Item ID: D206-667-247TRN

Item Name: Crosstube Assembly, Mid Aft

DART AEROSPACE LTD	Work Order:	96768
Description: Crosstube Assembly, Mid Aft	Part Number:	D206-667-247TRN
Inspection Dwg: D206-667-247 Rev: A		Page 1 of 2

DRAWING NO. D206-667-247	TITLE CROSSTUBE ASS'Y (206L MID AFT)	REV. A	DART AEROSPACE LTD ENGINEERING ORDER		D.E.O. NO. D206-667-247-A-1	SHEET NO. SHEET 1 OF 1	SCALE NTS
DRAWN <i>qp</i>	CHECKED <i>ASS</i>	MFG. APPR. <i>KB</i>	APPROVED <i>IMP</i>		DE APPR. <i>#</i>		
DATE 11.07.15	DATE 11.07.20	DATE 11.07.21	DATE 11/07/21		DATE 11.07.21

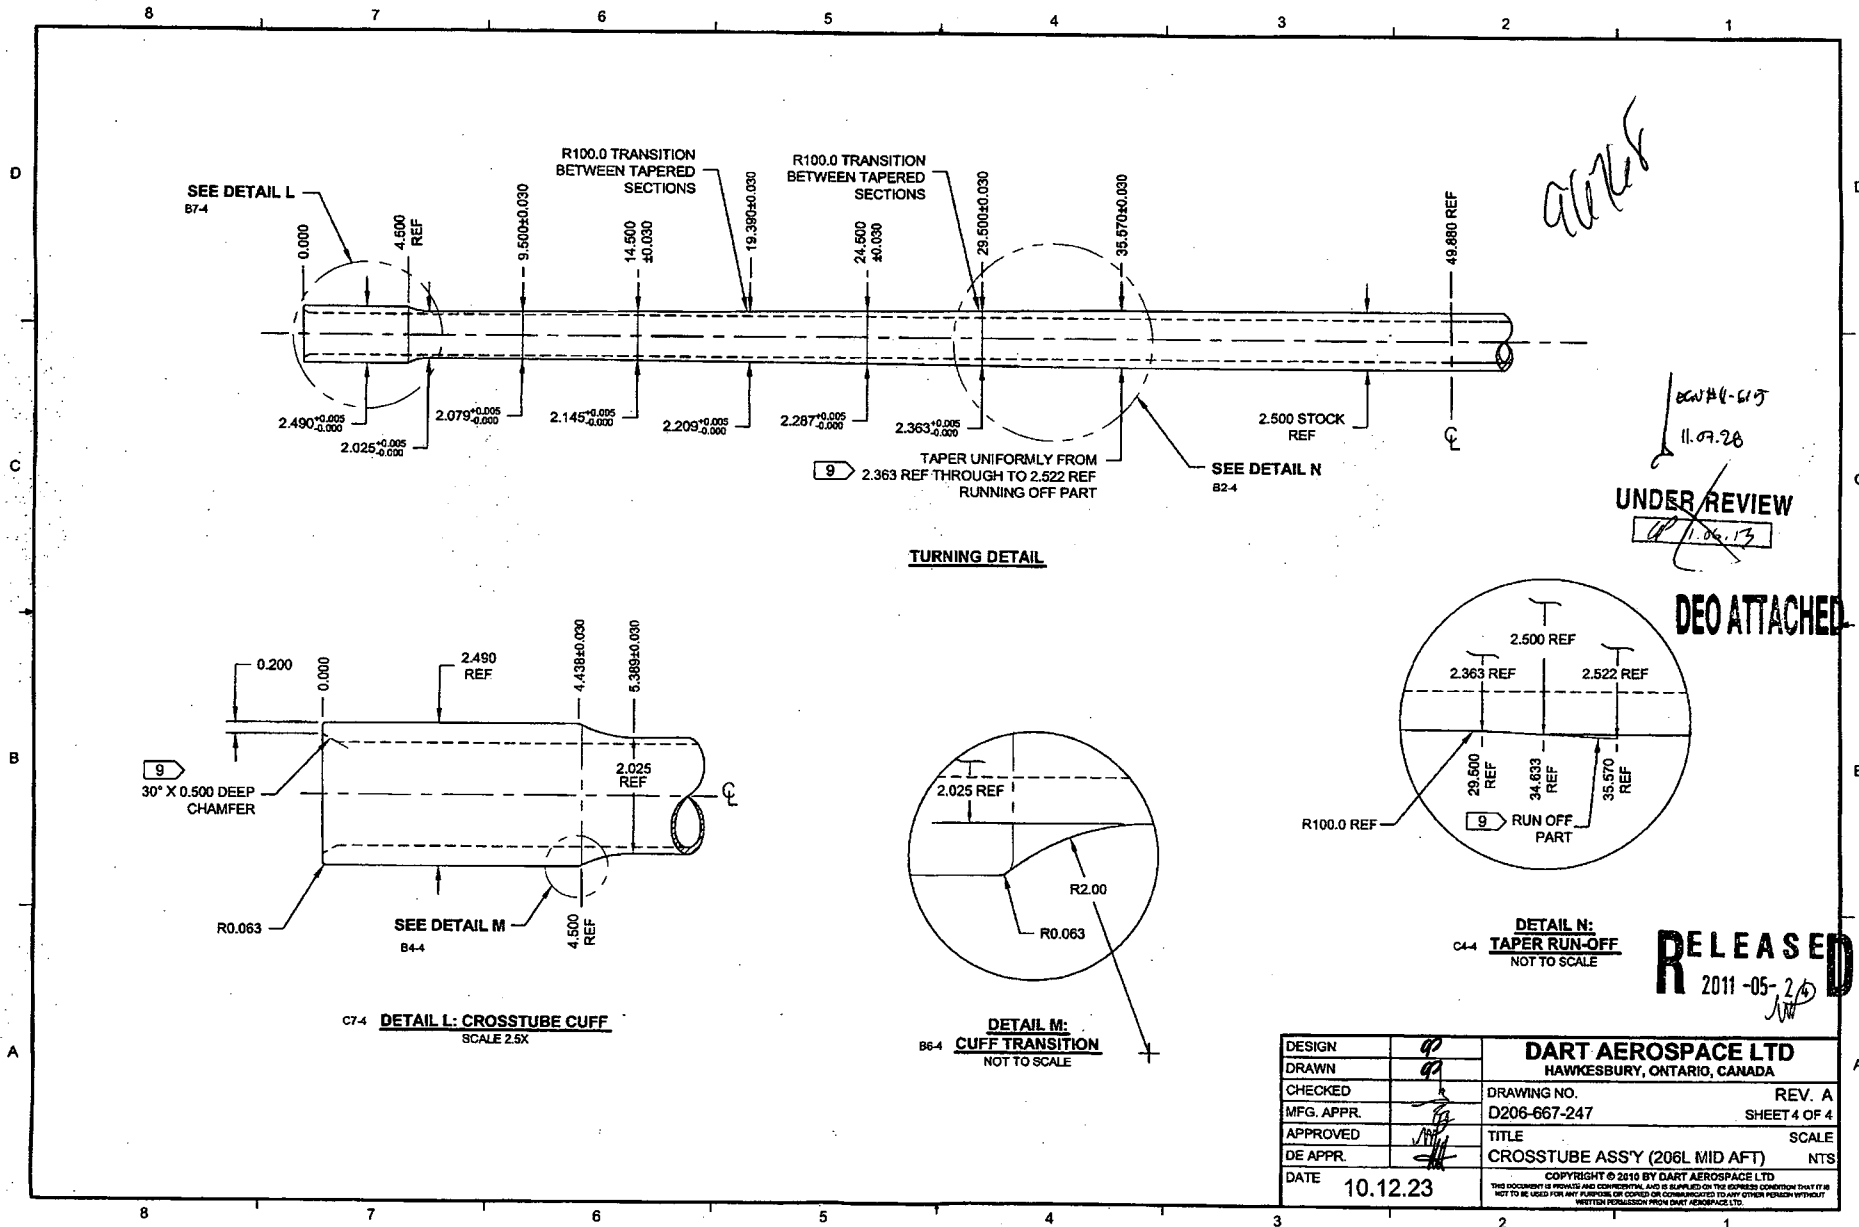
PURPOSE:

REPLACE MAGNOBOND WITH PROSEAL

IS:

Item	Qty -247	Part Number	Description
9	A/R	PROSEAL 890 B-2	SEALANT, AMS-S-8802 CLASS B-2

WAS:

9	A/R	MAGNOBOND 6398	ROCKWELL SPECIFICATION RBO-120-023 ADHESIVE (TEXTRON/BELL SPEC. 299-947-100, TYPE II, CLASS 2 ADHESIVE)
---	-----	----------------	---

NOTE 12 & 15, SHEET 1 IS AMENDED AS FOLLOWS:

WAS:

- 12) INSTALL D2892-1 SUPPORT USING 0.03" TO 0.06" THICK LAYER OF MAGNOBOND 6398 PER QSI 015. LET CURE FOR 12 HOURS AFTER INSTALLATION AND PRIOR TO PACKAGING.
- 15) TORQUE CLAMPS 80 TO 100 IN-LB. ENSURE AT LEAST 1.5 THREADS SHOWING IN SAFETY AND THAT NUT HAS NOT BOTTOMED-OUT AFTER TORQUING.

IS:

- 12) TO INSTALL D2892-1 SUPPORT: ABRASE MATING SURFACE OF SUPPORT AND CROSSTUBE WITH 180-GRIT SANDPAPER AND REMOVE RESIDUE WITH MEK (OR EQUIVALENT). APPLY A 0.04" TO 0.07" THICK LAYER OF PROSEAL 890 CLASS B-2 (OR AMS-S-8802 CLASS B-2) SEALANT TO MATING SURFACE OF SUPPORT.
- 15) TORQUE CLAMPS 80 TO 100 IN-LB. ENSURE AT LEAST 1.5 THREADS SHOWING IN SAFETY AND THAT NUT HAS NOT BOTTOMED-OUT AFTER TORQUING. **PRIOR TO PACKAGING, RE-CHECK TORQUE ON CLAMPS AFTER PROSEAL 890 SEALANT HAS CURED FOR 72 HOURS.**
